REPLACES: This Recall campaign replaces Recall MC 09-01 issued January 6, 2009, for eligible ZG1400A8F/L, B8F/L, A9F/L, B9F/L models only.

MODEL: 2008 ~ 2012 Concours™14 & 14 ABS (ZG1400A8F/L, B8F/L, A9F/L, B9F/L, CAF/L, CBF/L, CCF/L, DAF/L)

TITLE: REAR MASTER CYLINDER ROD END REPLACEMENT

RECALL

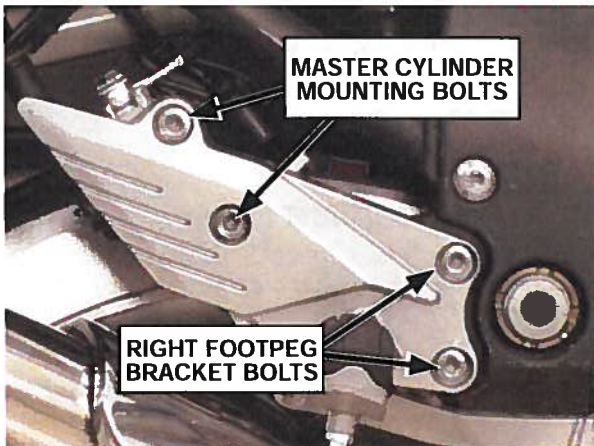
- Remove and retain the master cylinder mounting bolts.
- Remove and retain the right footpeg bracket bolts.

- Remove and discard the brake pedal bolt and washer.
- Remove and discard the brake pedal guard.

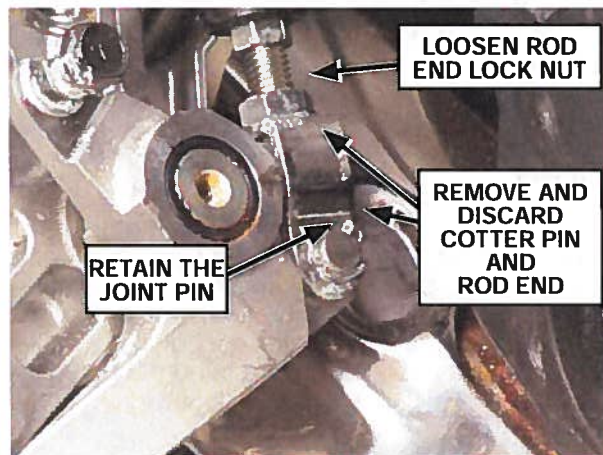
- Temporarily install the rear brake pedal assembly on the footpeg bracket.
- Loosen the master cylinder rod end lock nut.

- Remove and discard the cotter pin.
- Remove and retain the joint pin.
- Remove and discard the rod end.

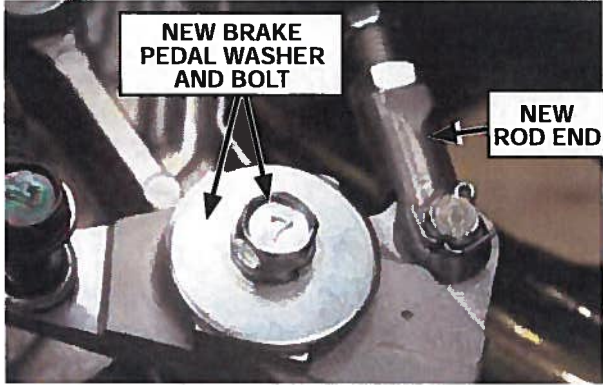
- Install the new rod end from the repair kit
- Install the joint pin.
- Install the new cotter pin from the repair kit.
- Install the new brake pedal washer and bolt from the repair kit and tighten the bolt to 8.8N·m(0.90 kgf-m, 78in-lb).

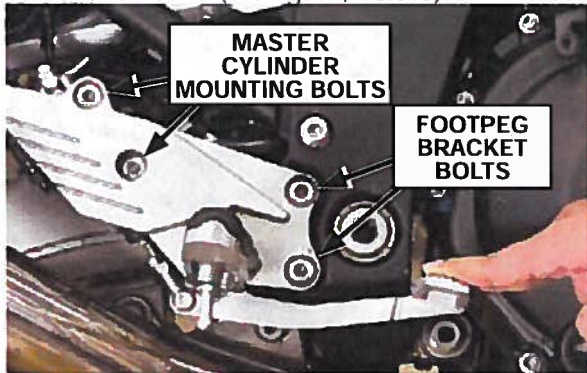
- Install the right footpeg bracket and tighten the bolts to 25N·m(2.5 kgf-m, 18ft-lb).

- Depress the brake pedal to align the master cylinder bolt holes, install the bolts, and tighten the bolts to 25N·m(2.5 kgf-m, 18ft-lb).

ZG1400A8F/B8F Brake Pedal Height Adjustment

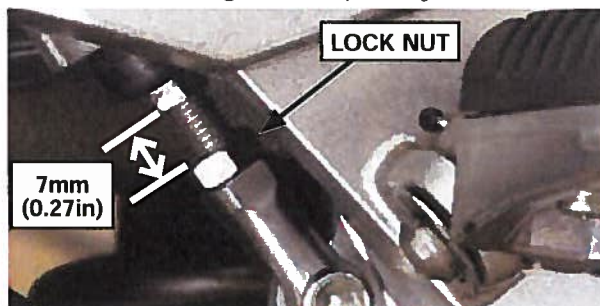
- Adjust the rear master cylinder push rod to a length of 7mm (.27in) measured between the two nuts and tighten temporarily.

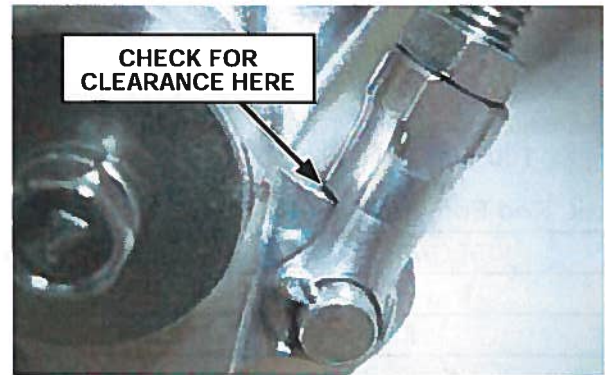
- Check for clearance between the rod end and the top of the brake pedal.

- Adjust (lengthen) the rear master cylinder push rod to achieve the least amount of clearance possible without binding the rod end, brake pedal, or master cylinder push rod. Do not exceed 9mm measured between the two nuts.
- Tighten the lock nut to 17.2N·m(1.8 kgf-m, 13ft-lb).

ZG1400A9F/B9F/CAF/CBF/CCF/DAF Brake Pedal Height Adjustment

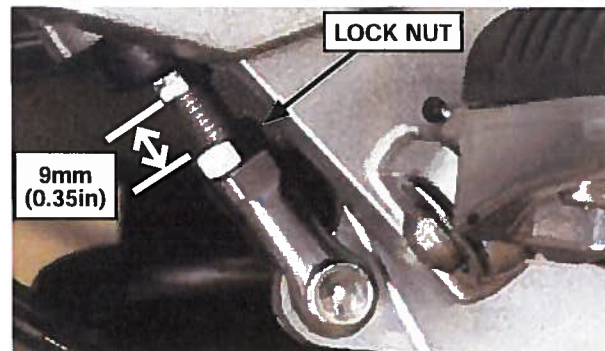
- Adjust the rear master cylinder push rod to a length of 9mm (0.35 in) measured between the two nuts and tighten the lock nut to 17.2N·m (1.8 kgf-m, 13ft-lb).
